RE: Wayne Glen (formerly Richter Tract)
Conditional Use Stormwater Management Review
***Stormwater Management Review Letter No. 2 and
Geotechnical Review Letter No.1***

**Re: Wayne Glen Independent Carbonate Geology Study Review
Tredyffrin Township, Chester County, Pennsylvania
pH No. 1380.001**

**Re: Wayne Glen Independent Stormwater Review
Tredyffrin Township, Chester County, Pennsylvania
pH No. 1380.001**

Figure 1. Comparison of the stage storage curves for the regional basin; note that the two-year peak elevation (stage) under proposed conditions is 135.5.

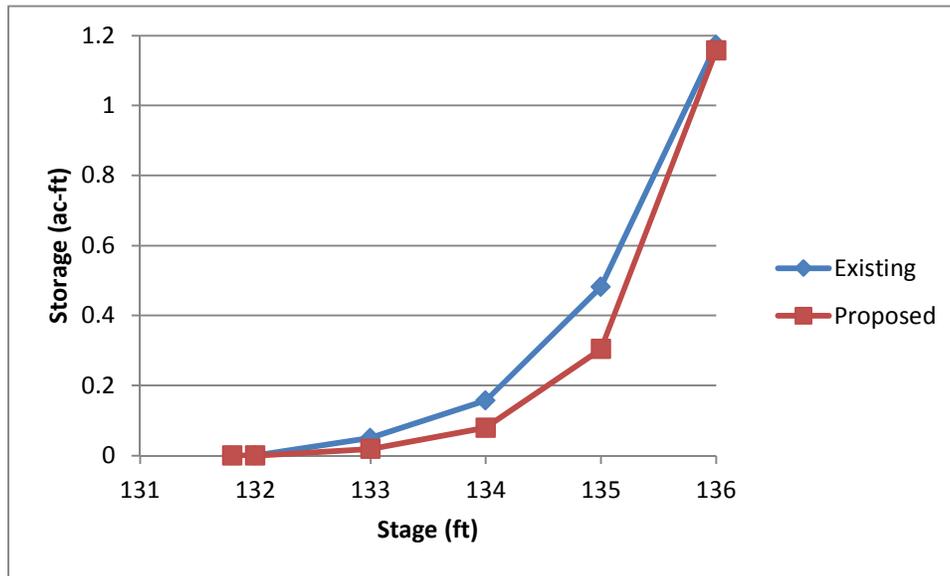
Contrary to the provided narrative, the comparison indicates that under proposed conditions the basin will actually have *less* storage available for the smaller (1 to 10-year) storms. Without actually routing storms through the existing and proposed regional basin we are confident that the modifications will *increase* peak outflow rates for these storms. These modifications will decrease the frequency and extent of overtopping at Walker Road but as a result, they will increase downstream peak flow rates for smaller more frequent storms.

In our original report we recommended that the existing calculations be completed with the existing “basin” explicitly represented. The engineer has not done this and offered the following statement in the narrative “The overlay ordinance specifically relates the performance of this basin to the Trout Creek Study. Our model utilizes the Trout Creek Study Model, which has been provided to us by the Township from that study; therefore, the existing flow data exactly matches that report.”

We do not agree with this interpretation and reiterate that, the original Trout Creek Study stated that any potential development in this area should “ensure that any modification of the existing Walker Road Culvert maintains, at a minimum, the same amount of storage or ponding upstream of the culvert as presently occurs so as to not reduce any attenuation that the existing culvert provides.”

The regional basin is a critical element of the proposed development. As such the peak flow rate control capabilities of the regional basin should be fully quantified so the Township has a clear understanding of how the proposed basin will function and can only then understand and weigh the trade-off between the frequency and severity of Walker Road overtopping and potentially *increased* peak flow rates.
